Patent No.: 6,400,126 B1

: SWITCHING REGULATOR WITH MULTIPLE POWER TRANSISTOR

TRANSMITTAL OF REQUEST FOR CERTIFICATE OF CORRECTION

UNITED STATES PATENT AND TRADEMARK OFFICE CERTIFICATE OF CORRECTION

In Sheet 1 of the drawings, FIG._4 should appear as follows:

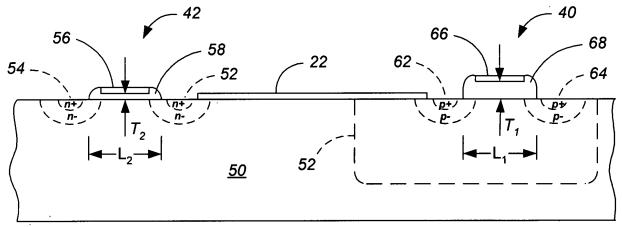
In Sheet 1 of the drawings, FIG._1, element 40 should show a PMOS symbol and element 42 should show an NMOS symbol.
